# WELLINGTON WATER EASTERN HILLS RESERVOIR

DISTRIBUTION			NUMBER OF COPIES				
CONNECT WATER			1	1	1		
WELLINGTON WATER			1	1	1		
		<b>ISSUE STATUS</b>	<b>FOR INFORMATION ONLY</b>	<b>ISSUED WITH CONCEPT DESIGN - FINAL</b>	<b>FOR INFORMATION ONLY</b>	<b>ISSUED FOR REVIEW</b>	<b>UPDATED POST INDEPENDENT REVIEW</b>

Title: COVER SHEET, DRAWING REGISTER  
AND TRANSMIT  
AND LOCATION PLAN

Discipline: CIVIL  
Drawing No. 3-WW021.02\_C000

Discipline	CIVIL
Drawing No.	3-WW021.02_W007
Rev.	1

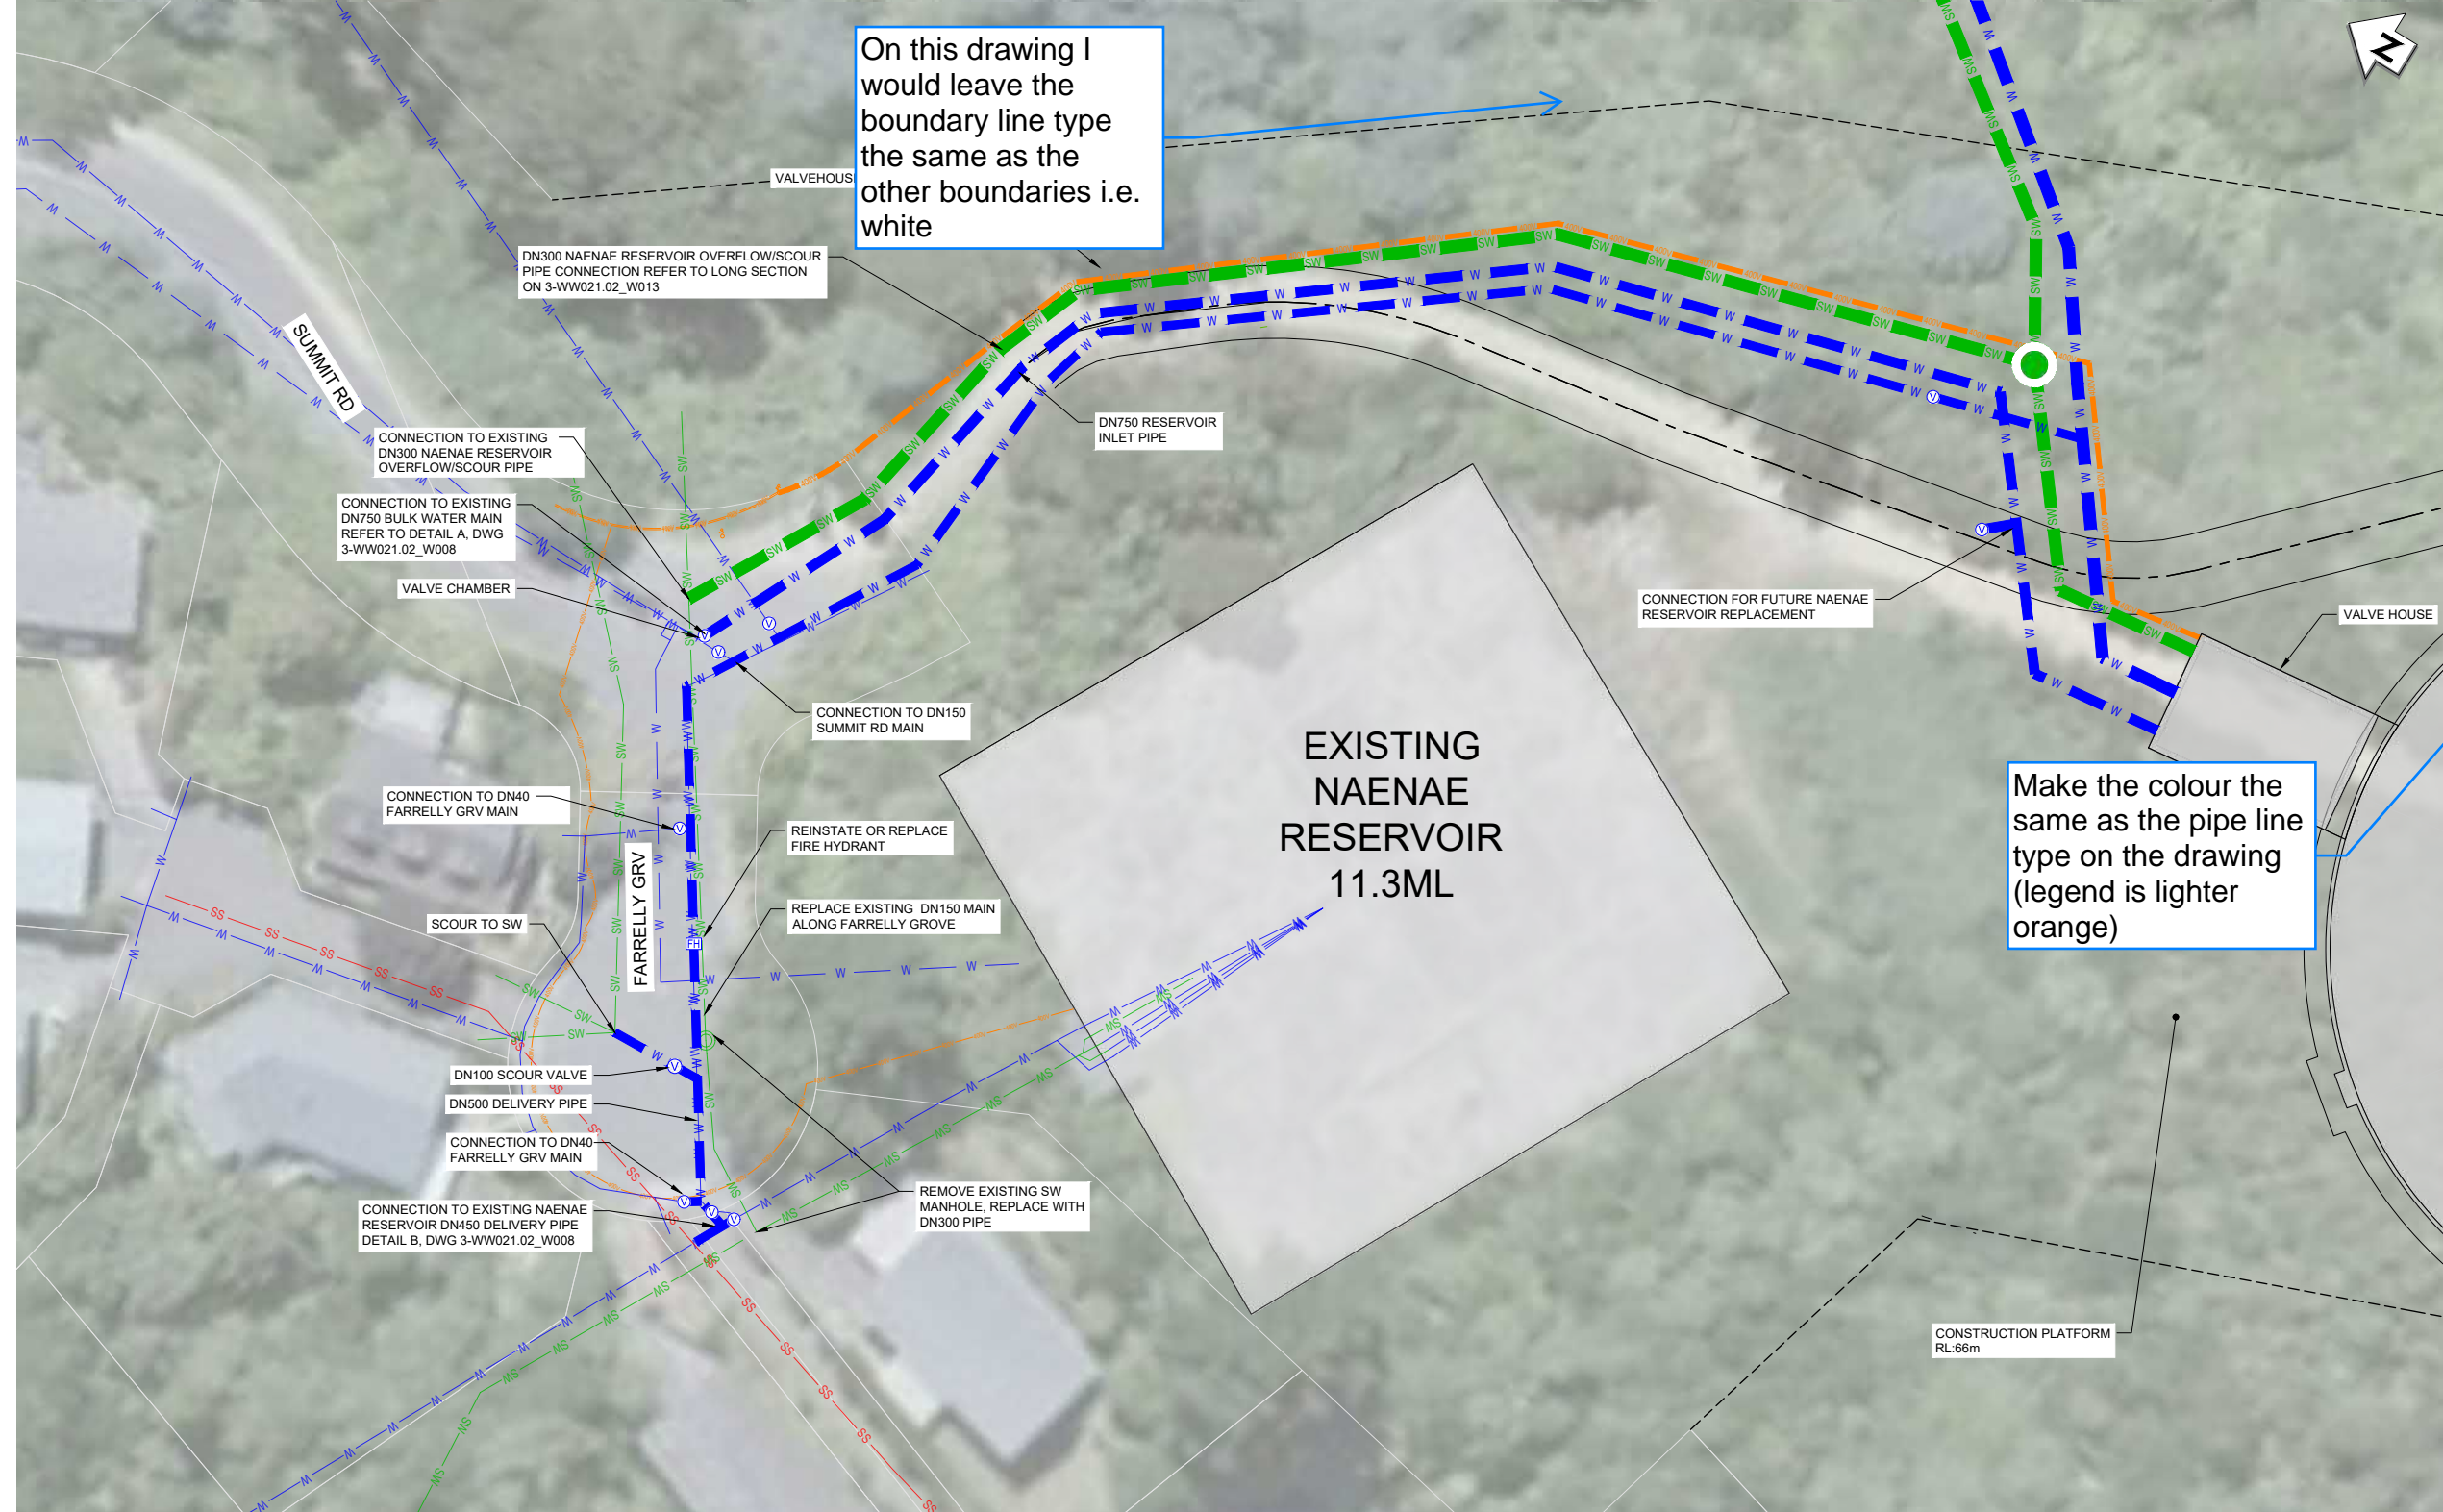
On this drawing I would leave the boundary line type the same as the other boundaries i.e. white

Make the colour the same as the pipe line type on the drawing (legend is lighter orange)
